## **NC State Building Codes Amendments - Effective 1/1/2015**

**(adopted through June 2014)**

The following pages represent a summary of the Building Code Council adopted amendments that have been approved by the Rules Review Commission.

**SECTION VIEW OF METAL FRAME ROOF:  
FILLED CAVITY FIBERGLASS INSULATION**

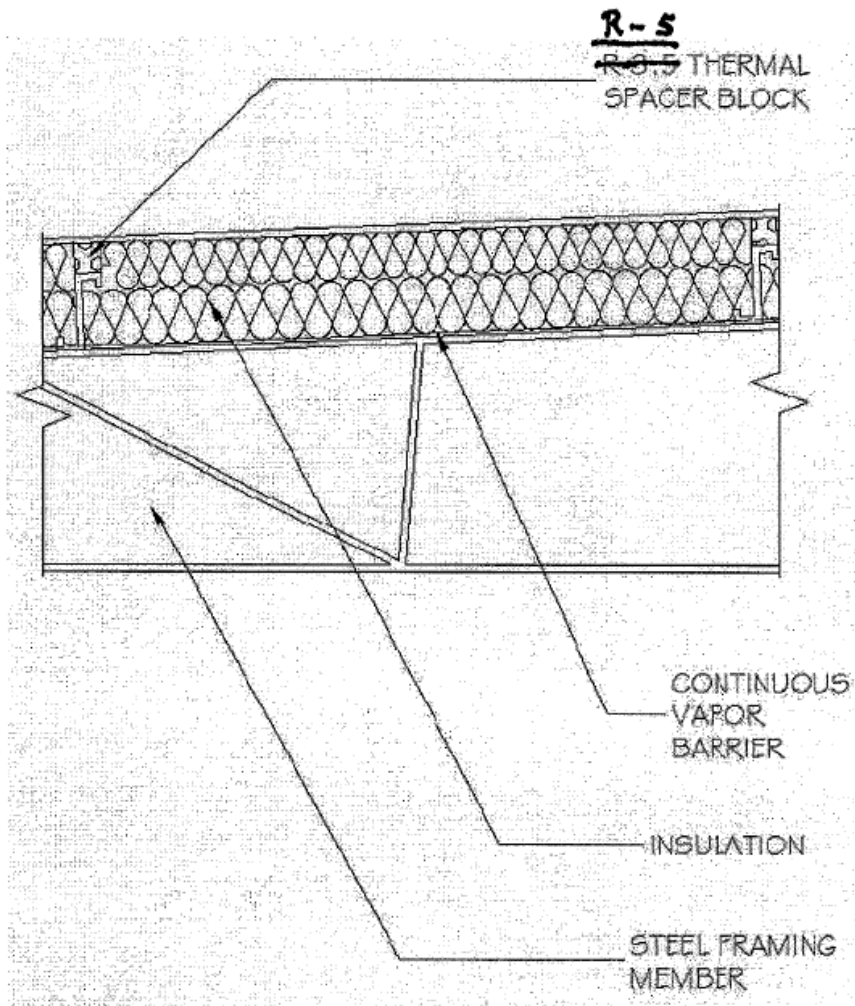
**TABLE 502.2(2)  
BUILDING ENVELOPE REQUIREMENTS – OPAQUE ASSEMBLIES**

| ROOFS             | DESCRIPTION  |
|-------------------|--|
| R-44 10 + R-19 FC | Filled cavity fiberglass insulation.<br>A continuous vapor barrier is installed below the purlins and uninterrupted by framing members. Both layers of uncompressed, unfaced fiberglass insulation rest on top of the vapor barrier and are installed parallel, between the purlins. A minimum R-3.5 thermal spacer block is placed above the purlin/batt, and the roof deck is secured to the purlins. Drawings of typical details are shown in Appendix 2.2. |

Revise Appendix 2.2 as follows:

**FIGURE R403.3 (1)  
CONCRETE AND MASONRY FOUNDATION DETAILS**

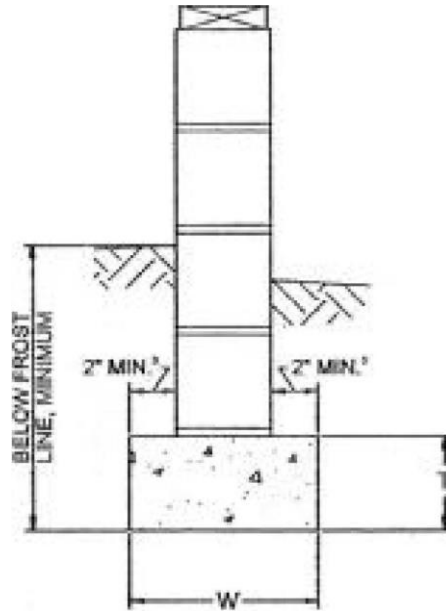
1. Foundations shall extend not less than 12 inches below ~~the natural grade or engineered fill~~ finished grade and in no case less than the frost line depth.  
REMAINING NOTES TO REMAIN THE SAME
